Access Report

**Proposed Education
Establishment**
57 Carrington Street
WEST WALLSEND NSW

For: Allambi Care
Ref: LP_21212

Architectural documentation for the Proposed Educational Establishment located at 57 Carrington Street West Wallsend, has been reviewed for the purposes of a State Significant Development Application, against current accessibility legislation.

Figure 1 | The Affected Part – Ground Floor

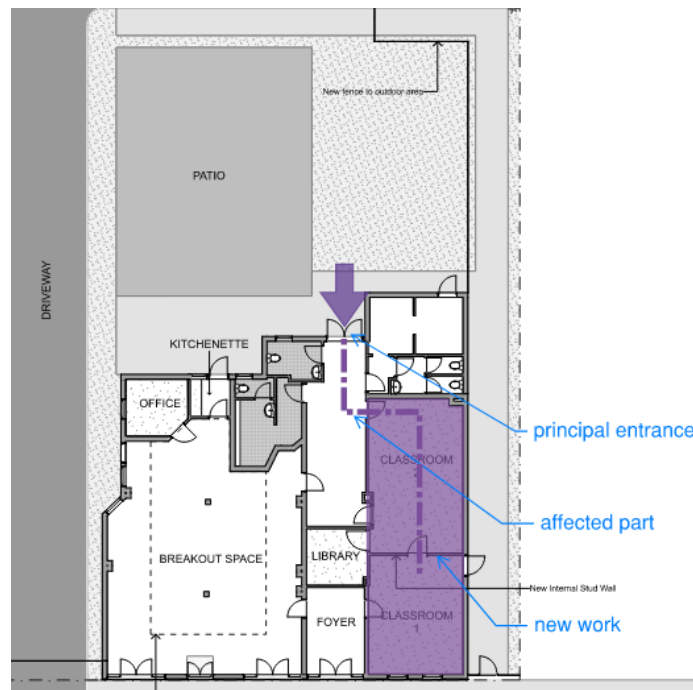
In this instance, the **new work** is the construction of the partition wall to create two (2) classrooms. The **affected part** is the path of travel from the principal entrance to the classrooms, which is an existing condition.

The rear entrance doorway has been established as the principal pedestrian entrance with respect to accessibility, offering a relatively level entrance and providing access from the car parking area. All students will come to site with their youth workers, being transported by private vehicle.

The entrance from the Carrington Street footpath has an existing step that cannot be altered due to the heritage constraints imposed on the built form and façade.
